**GLENORCHY PLANNING AUTHORITY
ATTACHMENTS
MONDAY, 14 JULY 2025**

**5. PROPOSED USE AND DEVELOPMENT – NEW BUILDING FOR SPORT AND RECREATION
– 61 CLAREMONT LINK ROAD, CLAREMONT**

1: GPA Attachment 1 – Site plan, advertised plans and TasWater referral.....	2
2: GPA Attachment 2 - Referral officer reports.....	41

SITE HYDRAULIC SERVICES PLAN
SCALE 1:500

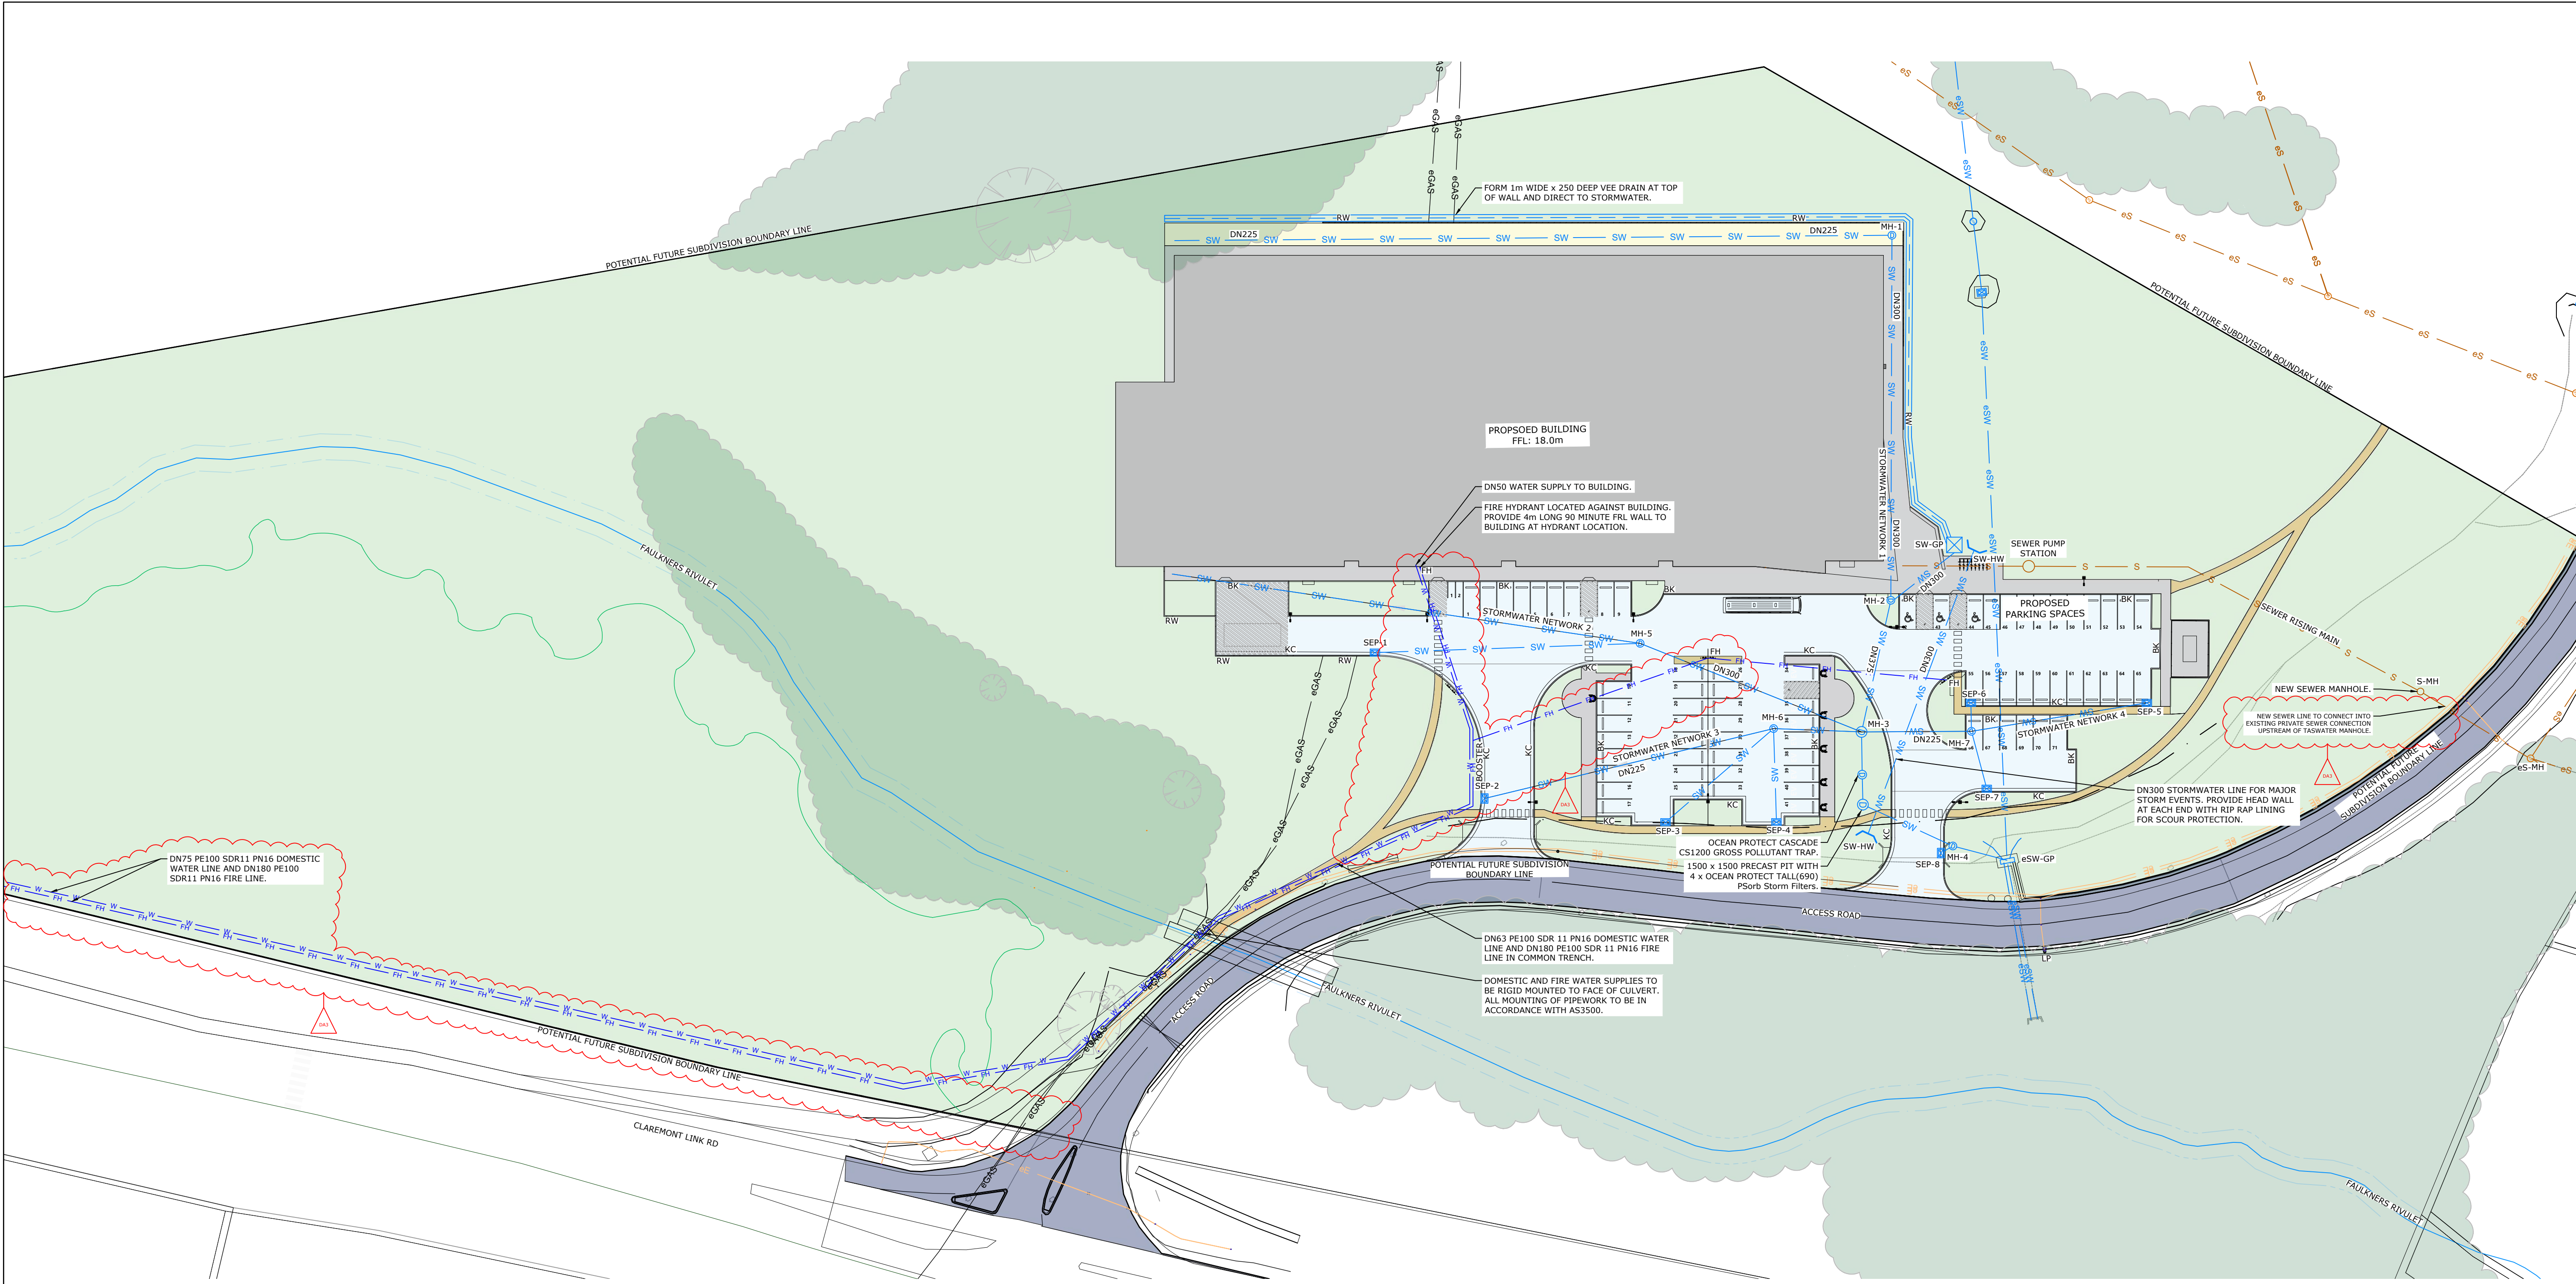
Prepared by	Drawing/document No.	Revision No.	Issue date
CES	C30, C31	DA3	14/05/2025

1. A suitably sized water supply with metered connections and sewerage system and connections to the development must be designed and constructed to TasWater's satisfaction and be in accordance with any other conditions in this permit.

5. Plans submitted with the application for Certificate(s) for Certifiable Work (Building and/or Plumbing) / Engineering Design Approval must, to the satisfaction of TasWater show, all existing, redundant and/or proposed property services and mains.

Figure 1 – Proposed Sports Facility

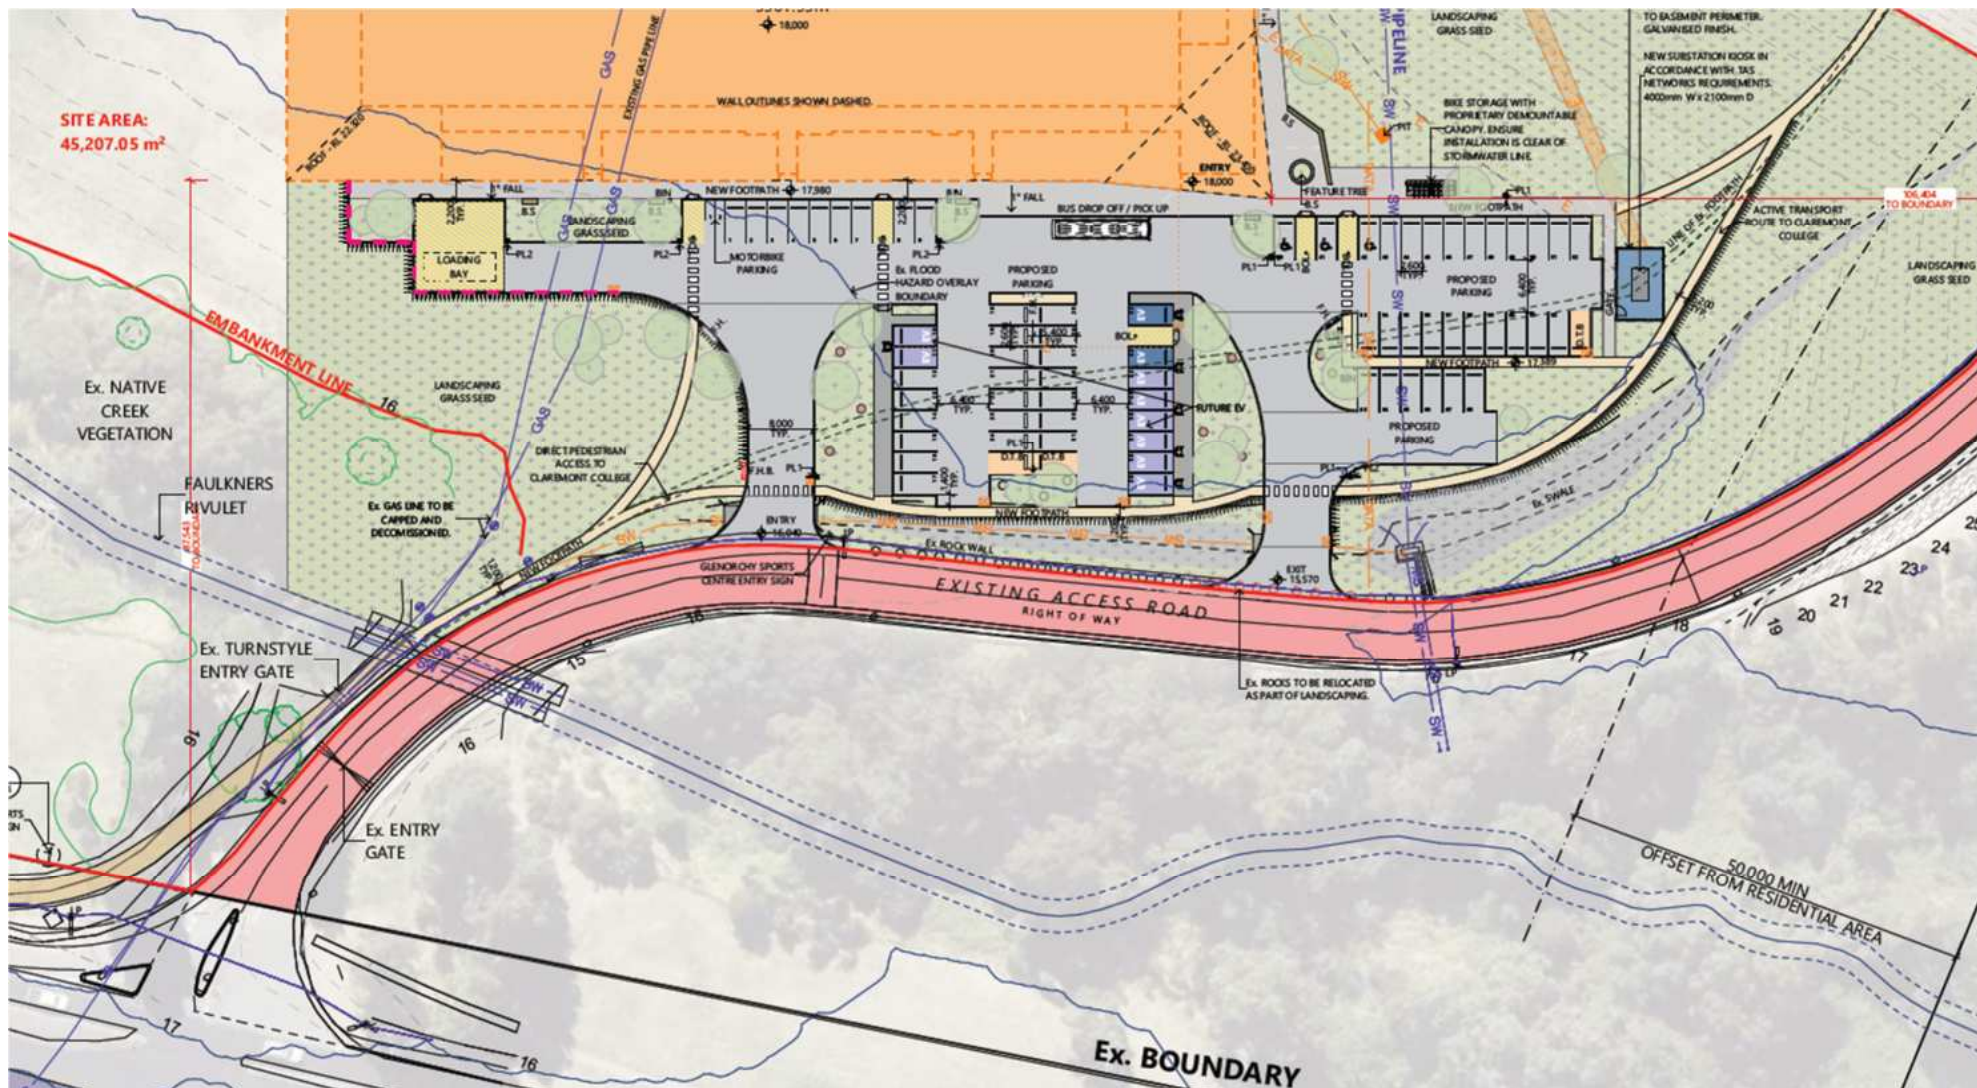
The car park will provide 63 car parking spaces, 2 motorcyclists spaces, a bike rack, a bus drop off zone and a loading zone. Of the 63 car parking spaces, three will be three accessible parking spaces and two will be EV charging station with the potential for more. The parking complies with the acceptable solutions in the planning scheme.

As the proposed sports facility will increase traffic on Claremont College access road by more than 20% or 40 vehicle movements per day (whichever is the greatest), the acceptable solution under C3.5.1 is not met and the TIA has addressed the performance criteria.

Figure 3 Post Development Flood Hazard Extents

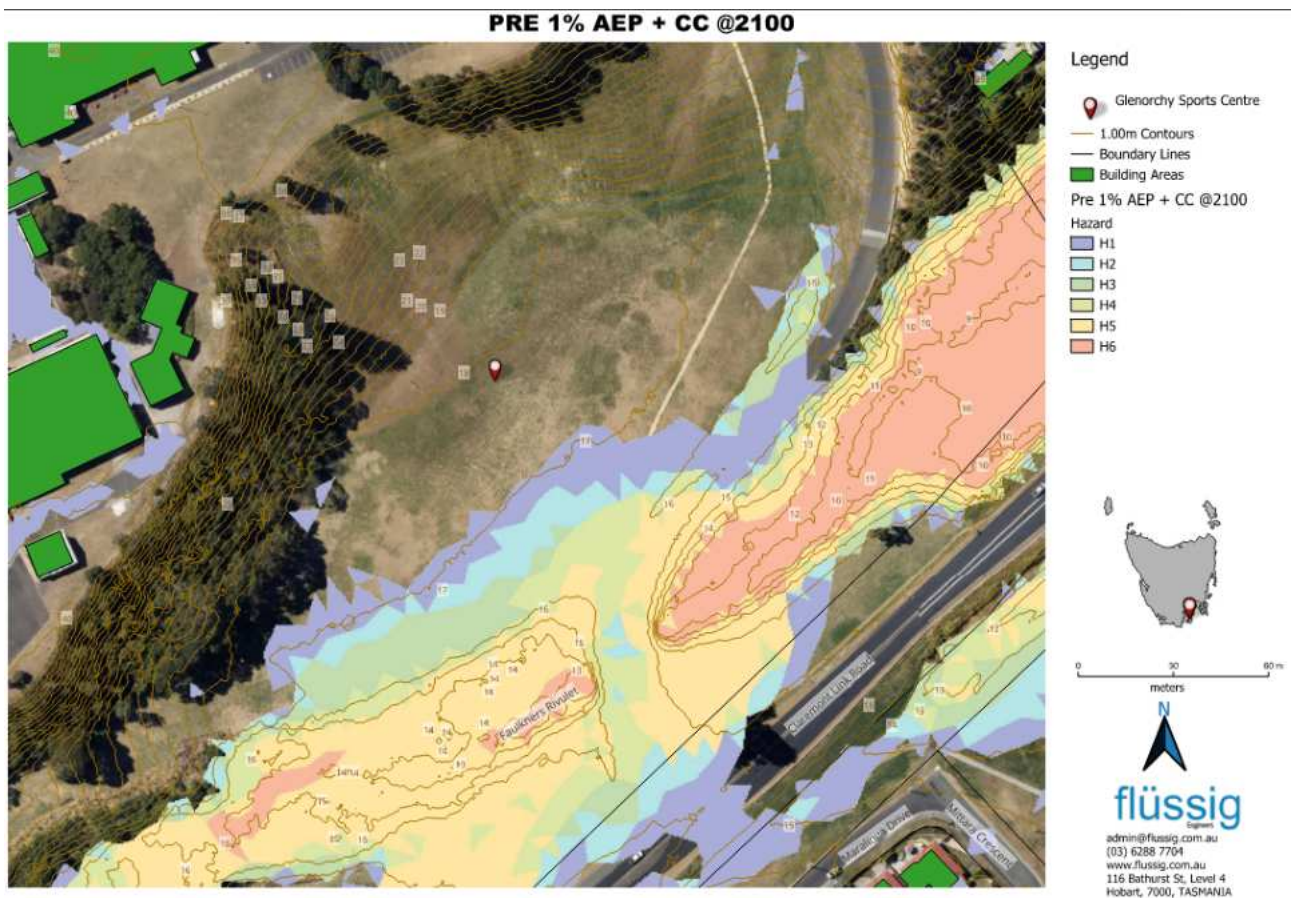
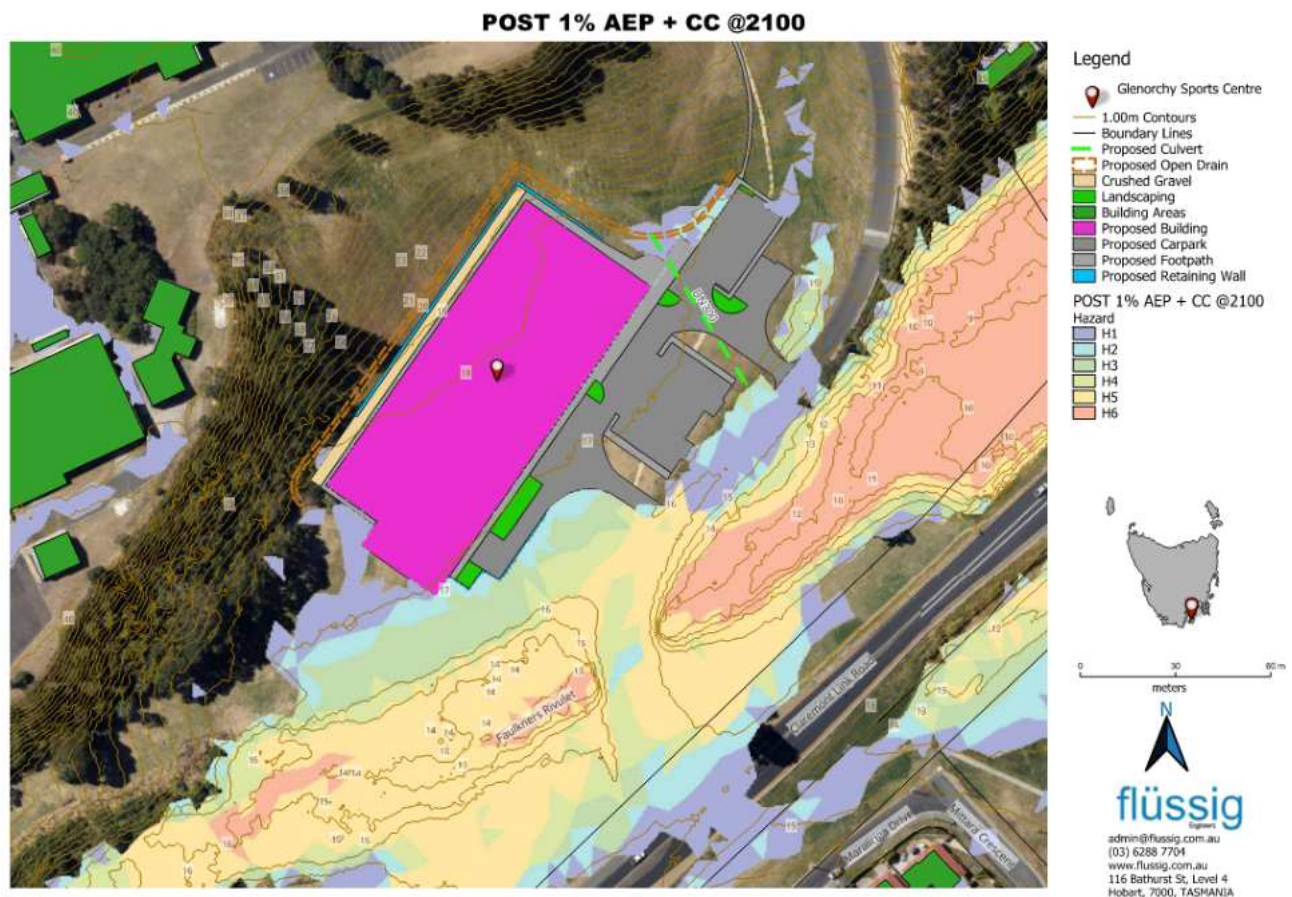
Flussig report has identified that the proposed developed of the multi-sport centre at 61 Claremont Link Road is susceptible to a fast moving and deep flood flow, with the surrounding region classified in the range H1-H6 hazard rating in the 1 % AEP + climate change event. This means some areas of the site are considered generally unsafe for people and vehicles.

- Raising the finished floor levels higher than the 1% AEP flood in accordance with Building regulations;
- Adoption and maintenance of flood management plans to all on-site facility users;
- No additional solid structures be constructed around the property without further flood assessment;
- Construct a new cutoff drain along the western side of the proposed facility, positioned at the top of the proposed retaining wall;
- Install a new DN300 pipe and associated pits to facilitate dewatering of the northern corner of the facility area, or implement any other structures that can achieve similar results; and
- Landscaping around the driveways and carpark areas should consist of stabilised, non-erosive materials.

- d) Provide details of the cutoff drain as recommended in Flussig Flood Hazard Report FE_24098_02 dated 07/02/2025. Drain lining material must be designed to convey flows safely without exposing for erosion. Include Flood Warning Signs and Safe Zone Areas plan as recommended in the FLOOD INUNDATION RISK MANAGEMENT PLAN FE_24098_02 dated 18/02/2025 by Flussig Engineers.
